ITEM B

PLANNING AND ZONING COMMISION

TITLE: **Royal Farms Store #323**

REQUEST: **Site Development Plan S-18-0012**
The Applicant is requesting Site Development Plan approval to develop a convenience store with gasoline pumps (Royal Farm Store #323), pursuant to City of Westminster Zoning Ordinance Section 164-75.D.(5)(a).

RFS 323 - SIGNAGE CHART

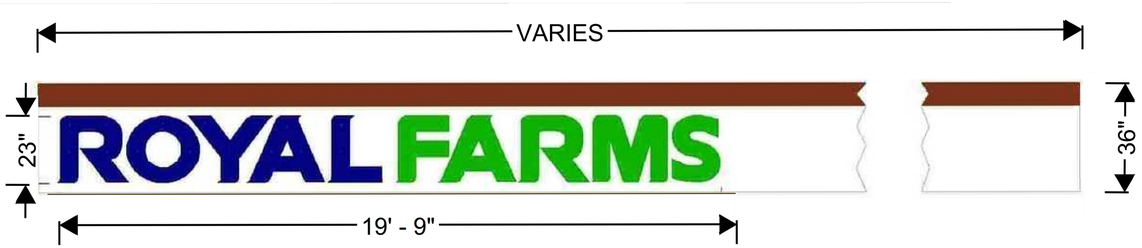
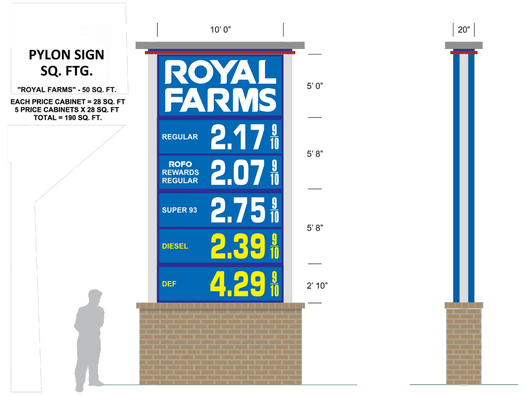
The Applicant is proposing a total of 512.31 square feet of signage with 190 square feet being attributed to the free-standing monument sign, with a brick base consistent with the architecture of the proposed Royal Farm building. S-18-0012 depicts the sign area dimensions of the monument sign as being 10 feet wide by 19 feet 2 inches wide but does not provide the height of the brick base. CP&D staff recommends that the Applicant should state the height of the brick base to the Commission and update S-18-0012 accordingly, so as not to have any issues at time of permitting for the monument sign. Otherwise, the proposed signage for S-18-0012 meets the requirements of the Zoning Ordinance.

FINAL LANDSCAPE PLAN

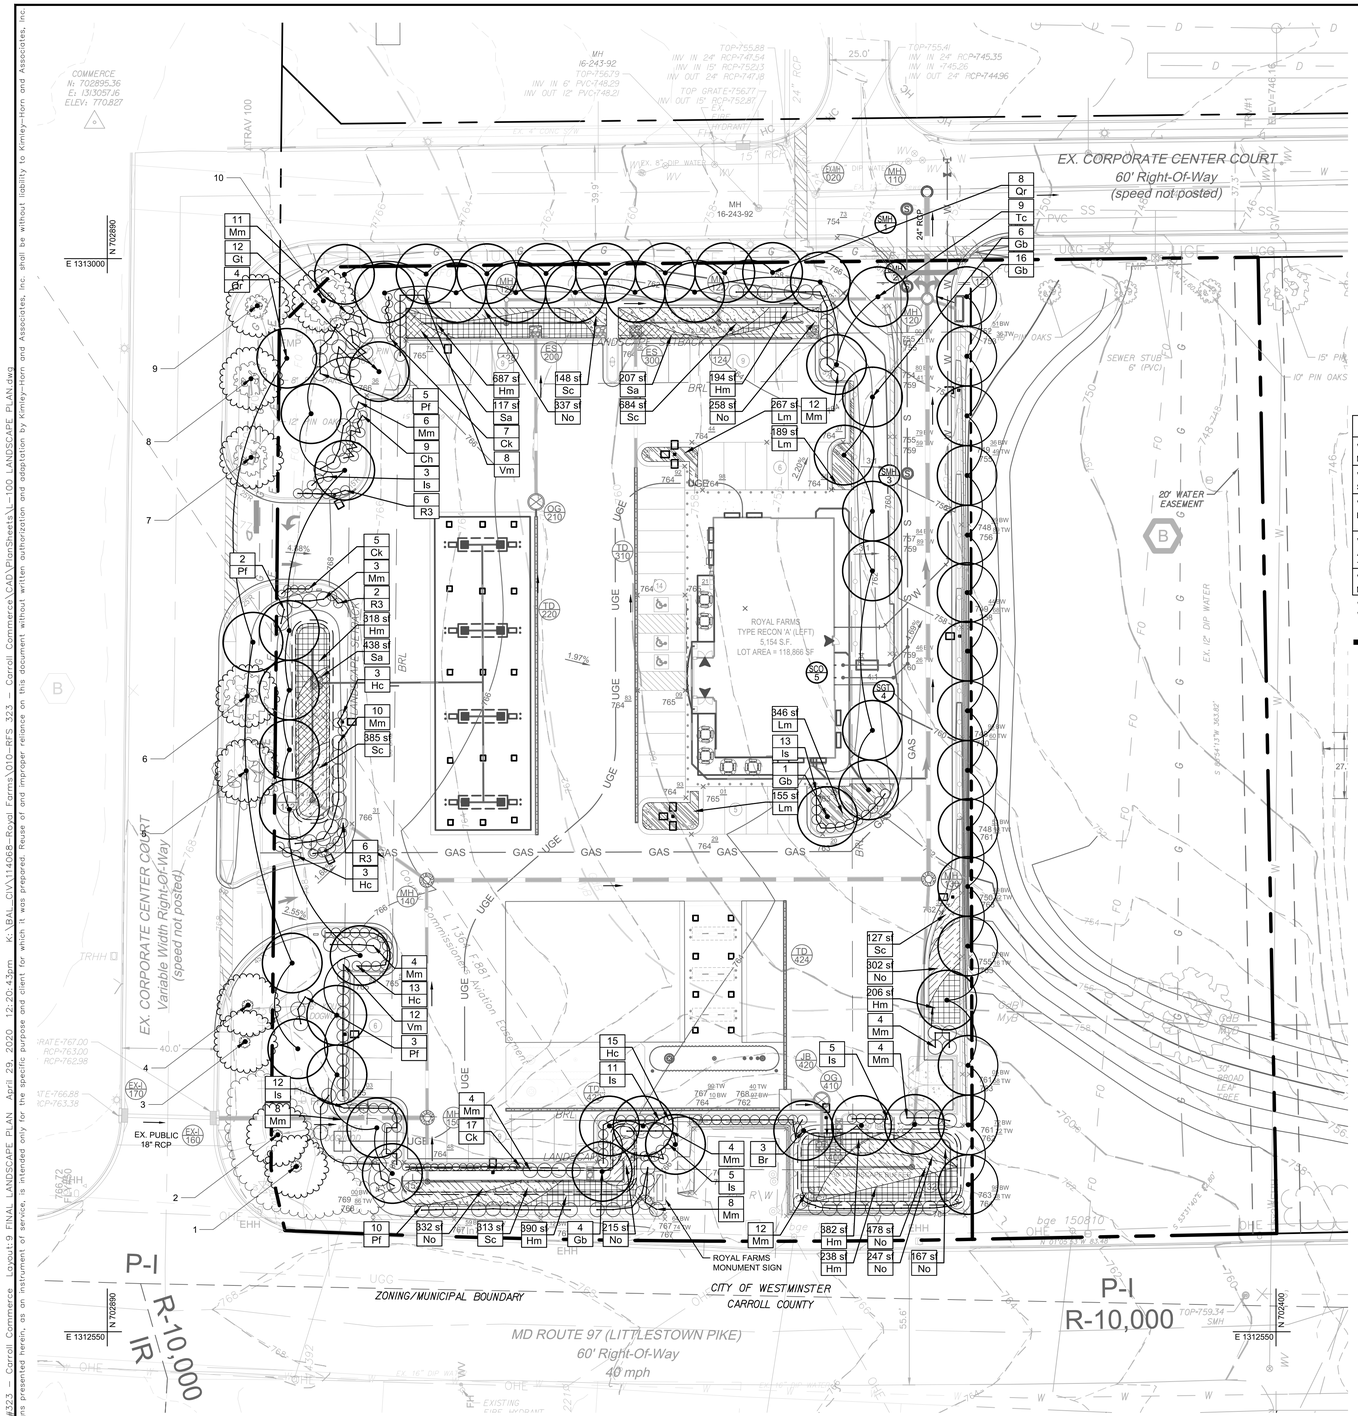
Pursuant to Zoning Ordinance Section 164-131.1., Compliance with Landscape Manual, CP&D staff has reviewed S-18-0012 for compliance with the Landscape Manual, as well as, the above referenced variances and other applicable Zoning Ordinance landscaping regulations. Pursuant to Zoning Ordinance Section 165-57, "*A thirty-foot-wide minimum landscaped edge shall be required along any residential district or external right-of-way, to be planted with a minimum of two-and-one-half-inch caliper trees at a minimum of 30 feet on center and a similarly landscaped earth mound at least three feet high between the parking area and any adjacent residential district or public right-of-way.*" [*Emphasis added*] S-18-0012 must provide the thirty-foot-wide minimum landscaped edge required along MD Route 97. Any approval by the Commission must be subject to S-18-0012 providing the required thirty-foot-wide minimum landscaped edge along MD Route 97. With the exception of the thirty-foot-wide minimum landscaped edge required along MD Route 97, S-18-0012 meets all other landscaping requirements of the Zoning Ordinance. However, CP&D staff is not aware of any landscape buffer being provided in lieu of meeting Zoning Ordinance Section 165-57 requirements, as stated by the Applicant and as outlined above, while meeting the required landscaping units

1 SITE PLAN - LIGHTING CALCULATIONS

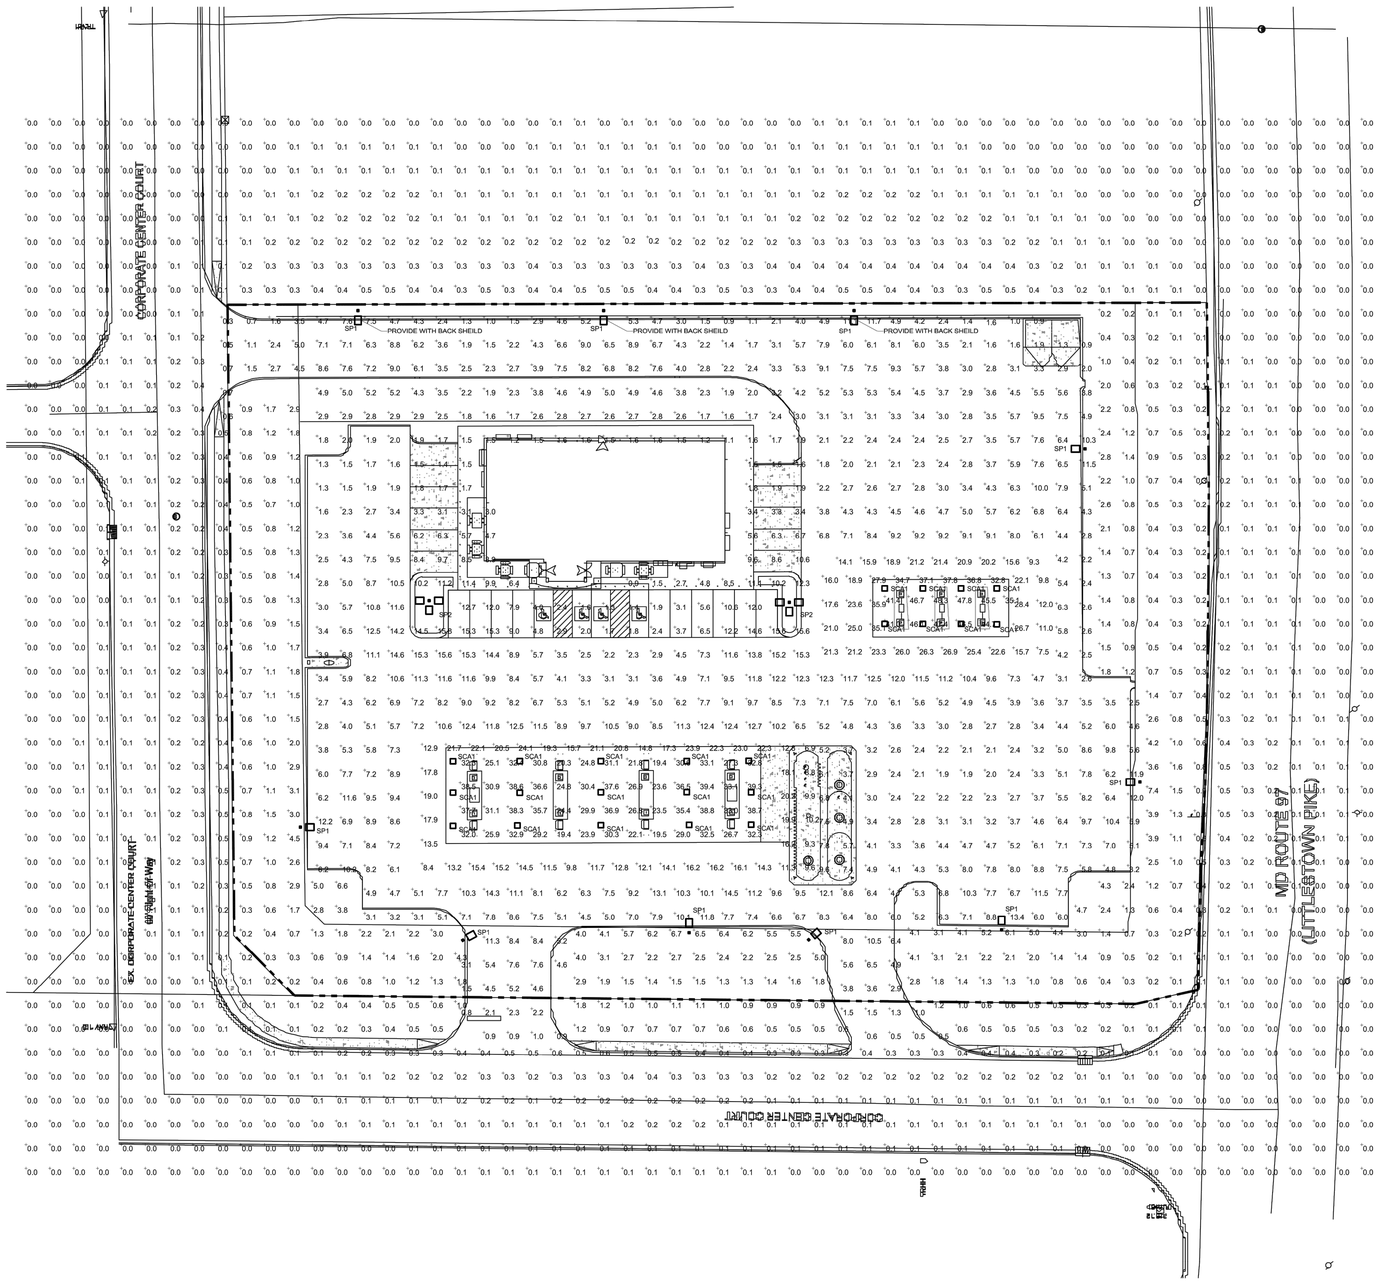
As referenced above, due to the approved variance, CP&D staff remains concerned with the lack of required plantings and screening intended to help screen the adjacent residential use across MD Route 97 form the proposed lighting for the Royal Farm development. Therefore, CP&D staff recommends that all site lighting to be directed away from the residential use across MD Route 97. CP&D staff also recommend that the Applicant provide comments on hours of operations and recommends that lighting should be extinguished by 10:00 p.m. or one hour after business hours ends if it is later than 10:00 p.m.

As referenced above, due to the approved variance, CP&D staff remains concerned with the lack of required plantings and screening intended to help screen the adjacent residential use across MD Route 97 form the proposed Royal Farm development. Therefore, CP&D staff recommends that all building and canopy signage perpendicular to or facing the residential use across MD Route 97 not be illuminated and site lighting to be directed away from the residential use across MD Route 97.
